**PLANNED UNIT DEVELOPMENT &  
SUBDIVISION STAFF REPORT****Date: January 22, 2009**

<b><u>DEVELOPMENT NAME</u></b>	Mount Island Place Subdivision
<b><u>SUBDIVISION NAME</u></b>	Mount Island Place Subdivision
<b><u>LOCATION</u></b>	2401 Old Government Street (West terminus of Old Government Street extending West to Mount Island Drive East)
<b><u>CITY COUNCIL DISTRICT</u></b>	District 5
<b><u>PRESENT ZONING</u></b>	R-1, Single-Family Residential
<b><u>AREA OF PROPERTY</u></b>	3.9± acres                      10 Lots
<b><u>CONTEMPLATED USE</u></b>	Single-family residential subdivision with reduced setbacks and a private street.
<b><u>TIME SCHEDULE FOR DEVELOPMENT</u></b>	Under Construction

## DETAIL SITE PLAN OF PARK STRIP

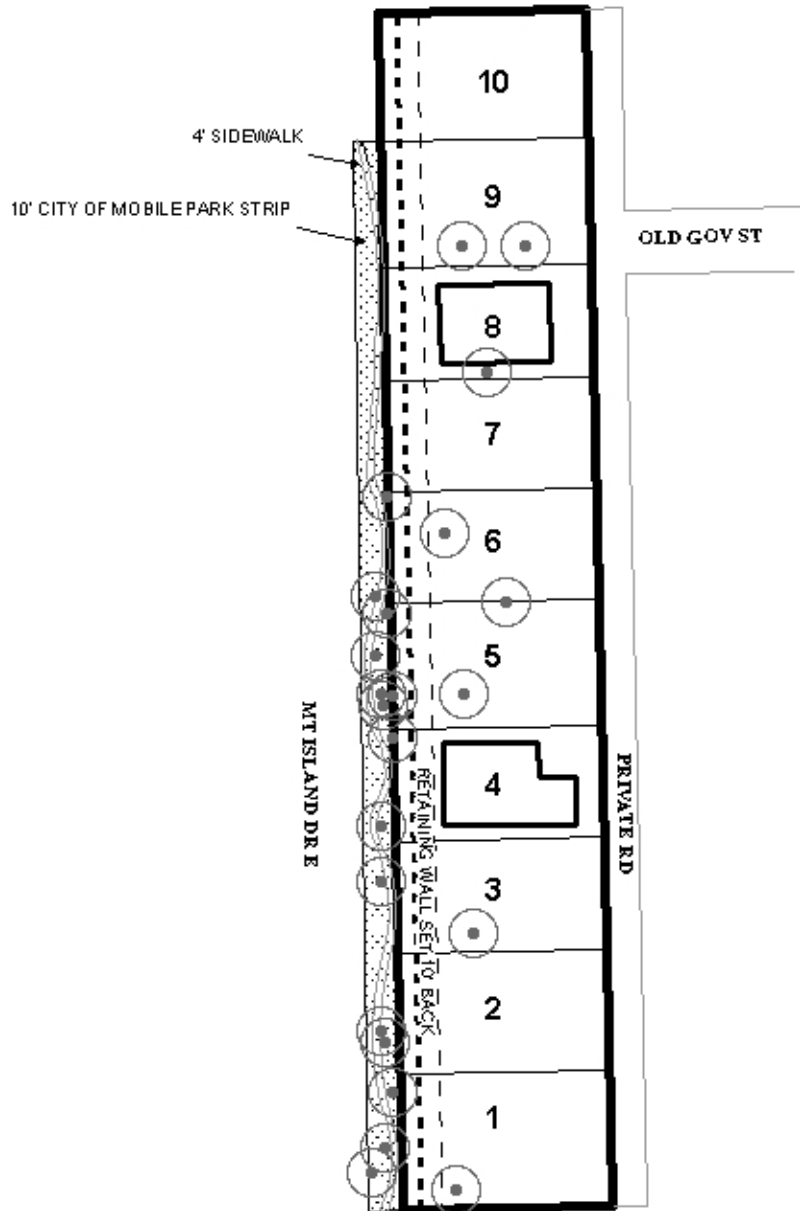
The applicant is now requesting that the conditions relating to the park strip and sidewalk location be either amended or removed. The applicant would like to construct a sidewalk on the Mount Island side, either meandering through the adjacent park strip (if approved by City Council) or on the private property next to the park strip. The applicant states that the council person for this area has been approached about installing a sidewalk in the remainder of the park strip (from Airport Boulevard to Mount Island Drive West), making a walking trail and thus use of a previously unused and unmaintained city property. The applicant also proposes to landscape and maintain the park strip adjacent to the site.

Another reason stated in the application for relocation of the sidewalk is the proximity of the sidewalk to the garage(s), and possible hazards to pedestrians from vehicles backing out of the garage.
